Re: Site Plan Review, ALE Addition, Bryant School District, Bryant, AR

Below is our response to the DRC comments:

BRYANT ALE CLASSROOM ADDITION

1 / A9.0 SITE PLAN

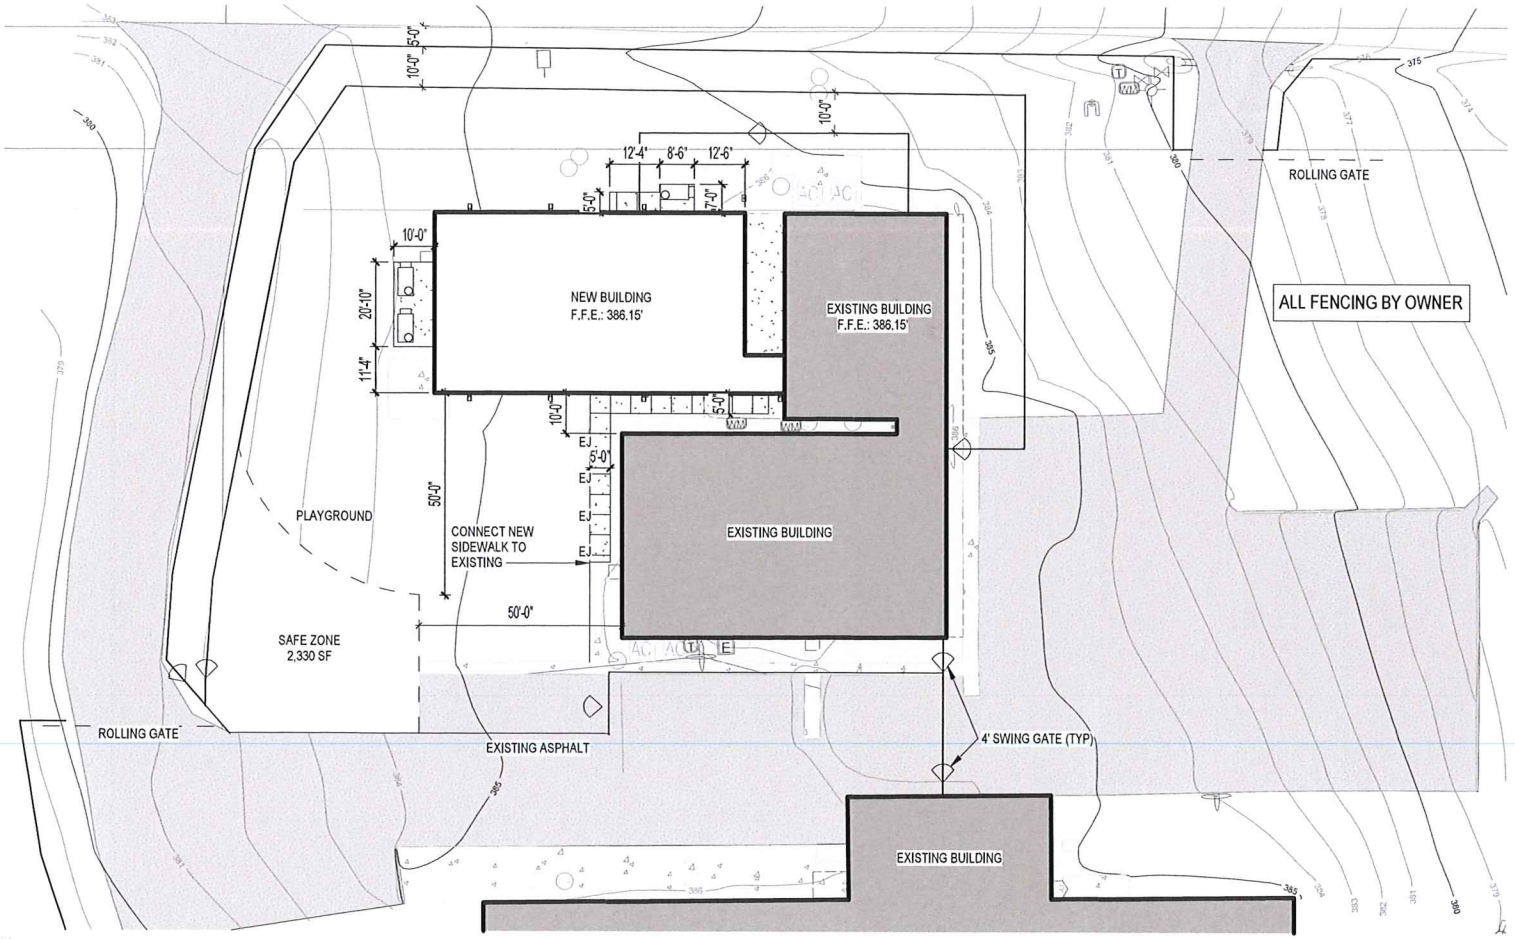
3. See attached Site Plan for fencing limits.

1. See attached Site Plan for fencing limits and Safe Zone requirements.
